Government of India Ministry of Railways

Thirty-sixth Meeting

Locomotive Standards Committee

January 1956

B.G LEADING AND TRAILING COUPLED AXLE (83 JOURNAL DIAMETER)-"WP" LOW NOTE:

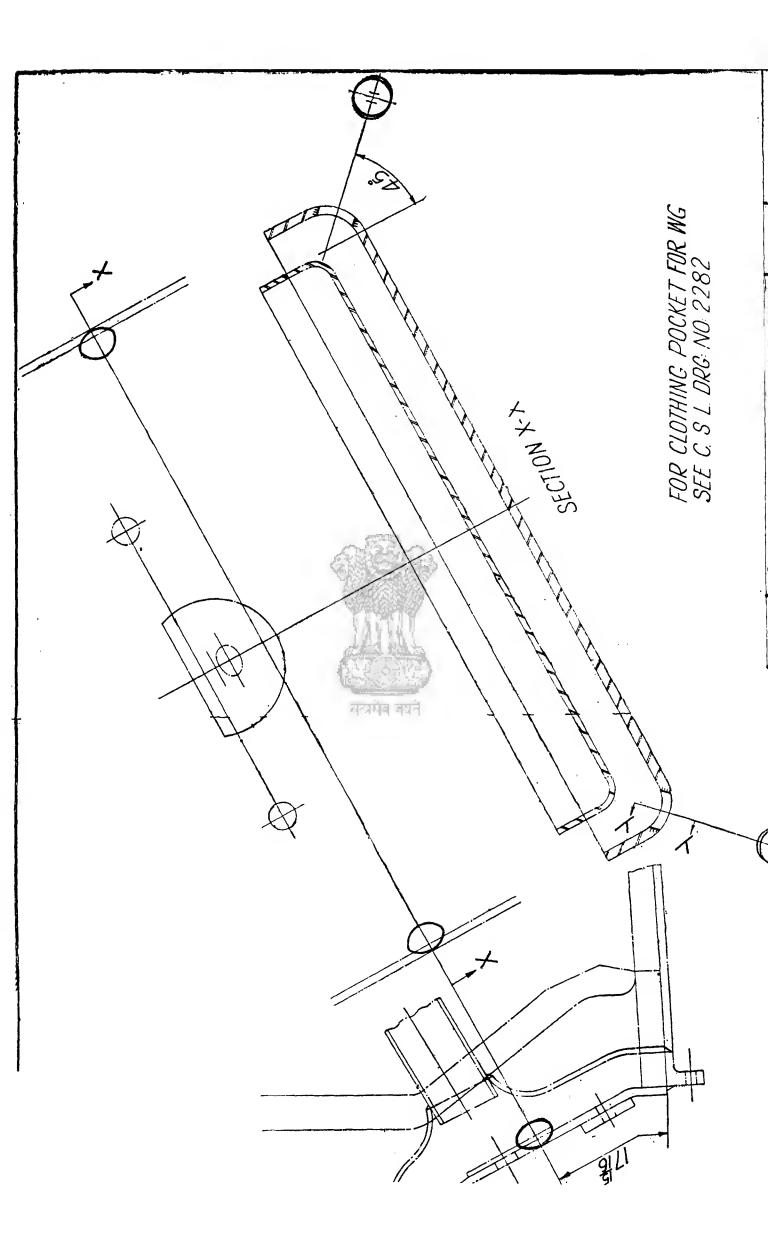
Para 41. For existing locomotives, the Committee recommends that the diameter of the leading and trailing coupled axles be increased to 8.3/8" as and when existing axles need to be replaced and the modifications shown in CSL Drawings 2284, 2285, 2286, and 2289 be followed in this connection.

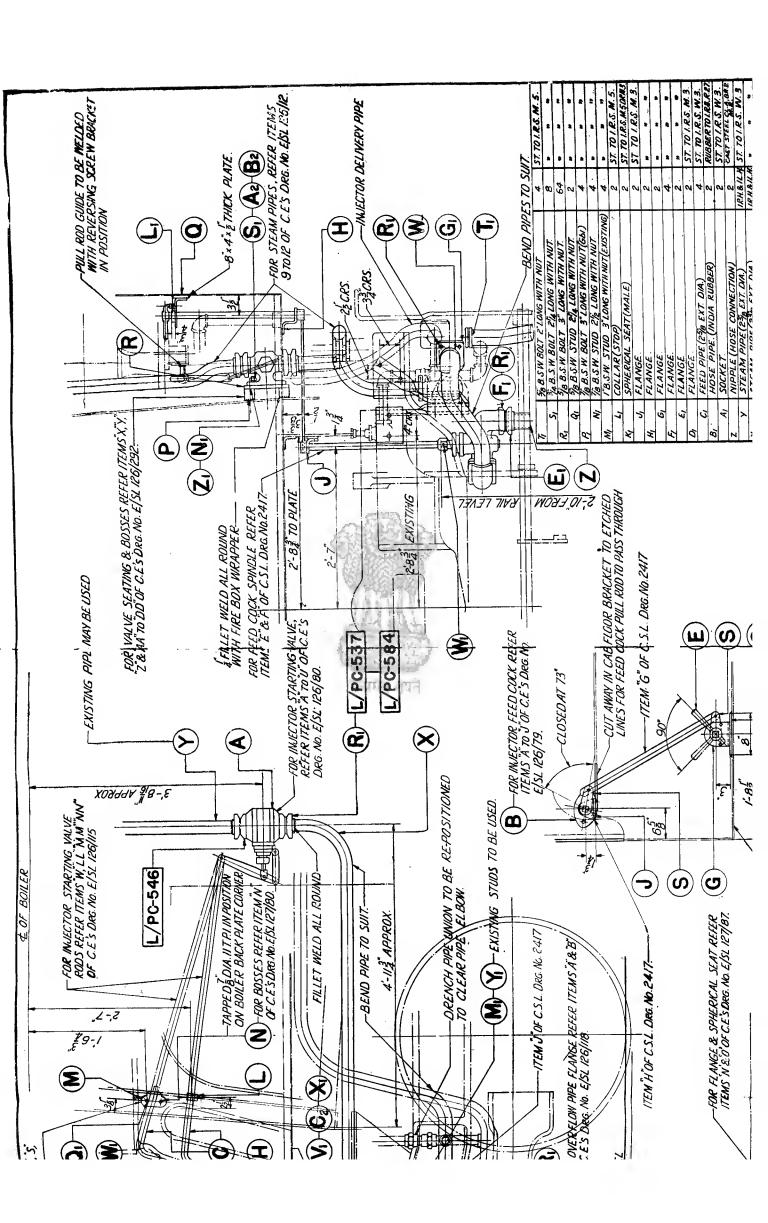
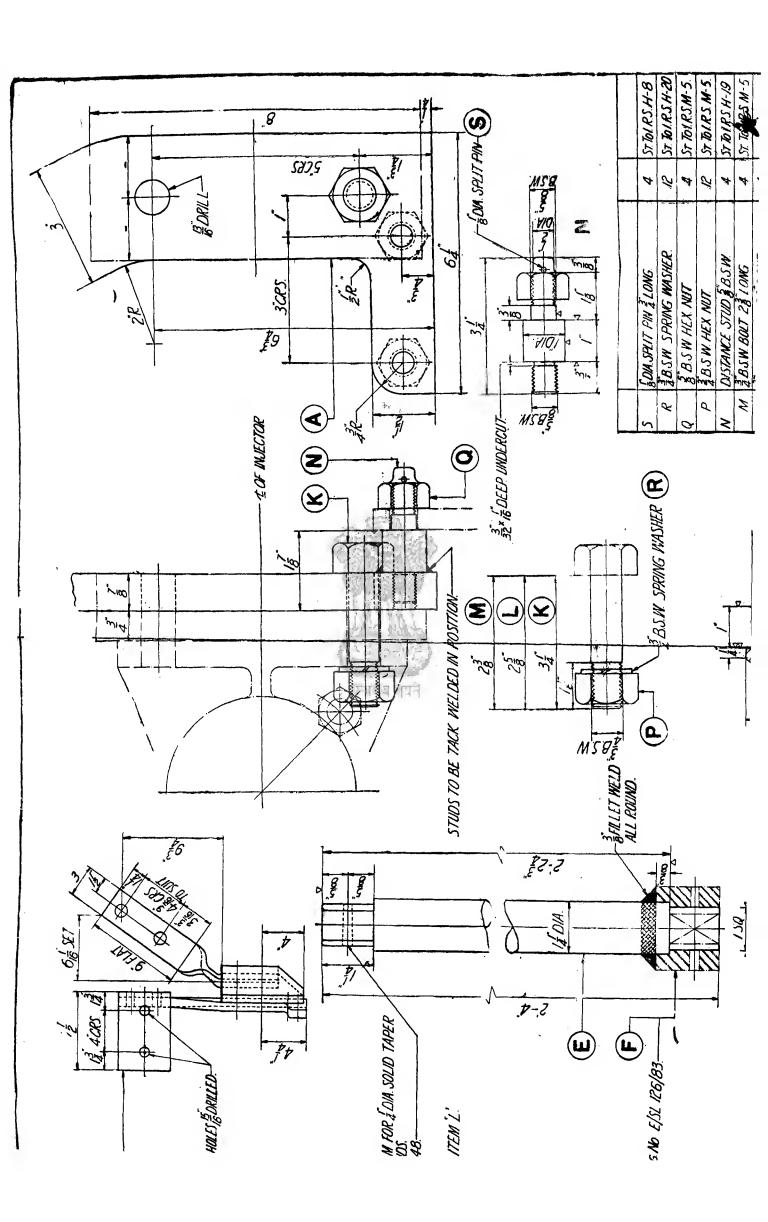
- 1. The locomotive (tank) engine required are described in the Schedu'e accompanying the tender documents and illustrated in CSL Drawing 2441 Alt. I appended to this Specification. The locomotives are to be built in accordance with the Indian Railway Standard Specification for Steam Locomotive Engines and Tenders, Serial No. R. 32-54, so far as it is applicable and with the requirements of this Particular Specification.

- VI. The drawings exhibited are listed in the appendices to this Particular Specification classified as follows -—
 - Appendix I. CSL Drawing 2441 Alt. 1 is a tentative outline of the 'WH' class locomotive (tank) engine now required and is given fer general guidance only.

MODIFIED COUPLED COMPENSATING BEAM PINTLE FOR WI ROUGH U ETCHEO LINE AUTH 2+000 SEATING 2+000 SEATING OESCRIPTION

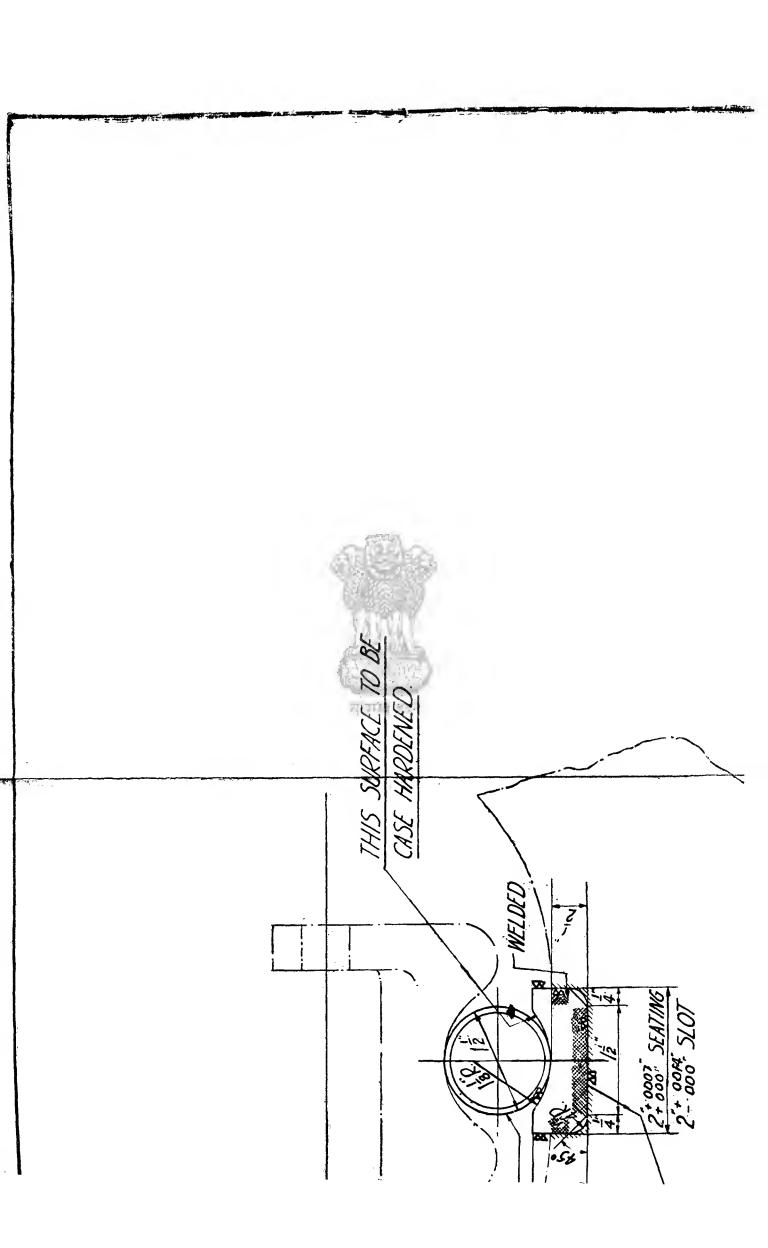
In line with these recommendations, the Committee may consider the adoption of Belleville washer auxiliary springs on coupled wheel hangers, and modified compensating beam pintles as shown in CSL Drawing 1989 and CSO Sketch L—90 respectively. The R. O. balance and inter-buffer load do not require any change as the figures quoted are existing values.
